March 29, 2022

RE: **Lot 22 Block 6 Volcano Cliffs Unit 22 SAD 228**
8009 Camino Alto
Grading and Drainage Plan
Engineers Stamp Date 7/25/2016 (D10D003B22)
Pad Certification Date 8/25/2016
Revised GP for Pool Date: 3/24/2022

ENGINEER'S SEAL 3/24/22 9/7/16 8/25/16 DAVID SOULE P.E. #14522	LOT 22 BLOCK 6 UNIT 22 VOLCANO CLIFFS SUBDIVISION	DRAWN BY JDG
	GRADING AND DRAINAGE PLAN	DATE 08-25-2016
 Rio Grande Engineering 1606 CENTRAL AVENUE SE SUITE 201 ALBUQUERQUE, NM 87106 (505) 872-0999		SHEET # 1 OF 1
		JOB #

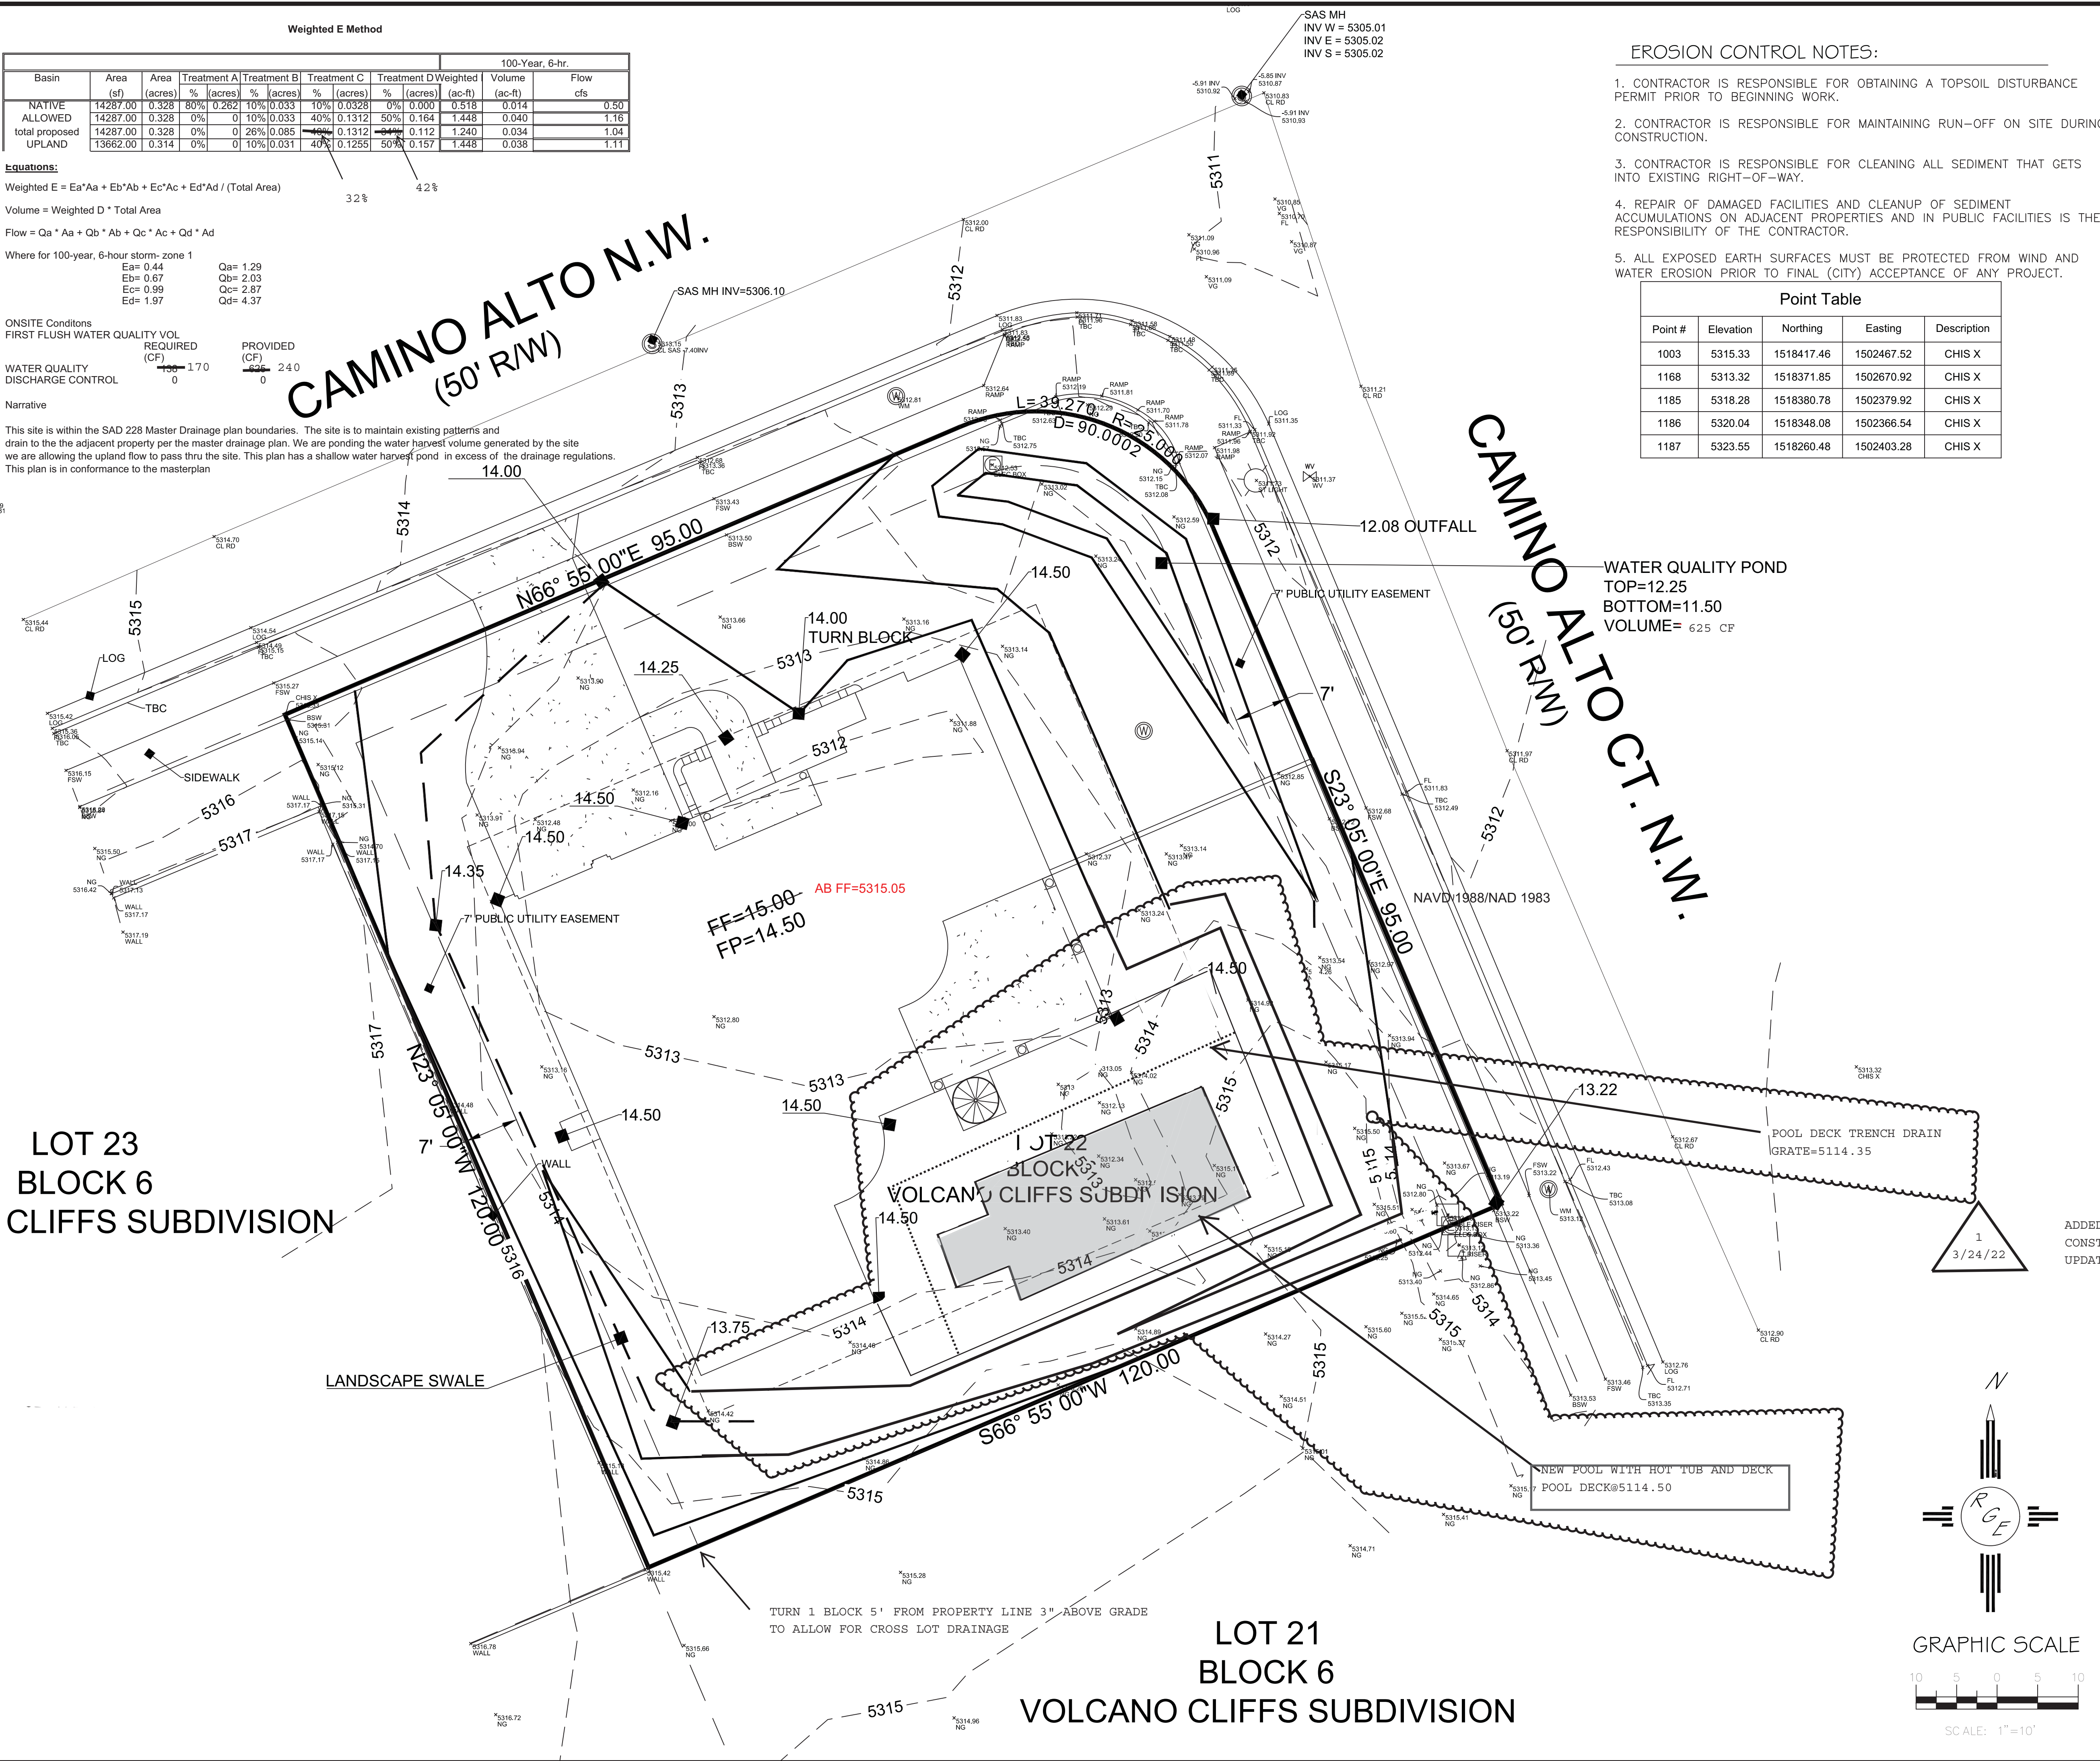
Based upon the information provided in your submittal received 3/28/2022, this plan is approved for revised grading plan.

Reiterate to the Owner/Contractor that a separate permit for a garden/retaining wall must be obtained, with the approved G&D plan and Pad Certification. Advise the owner & Contractor that dirt is not allowed in the public right of way to climb the curb. Crusher fines or lumber is allowed. If dirt is used this will delay going forward with the construction of the home.

Prior to Certificate of Occupancy release, Engineer Certification per the DPM checklist of this plan will be required.
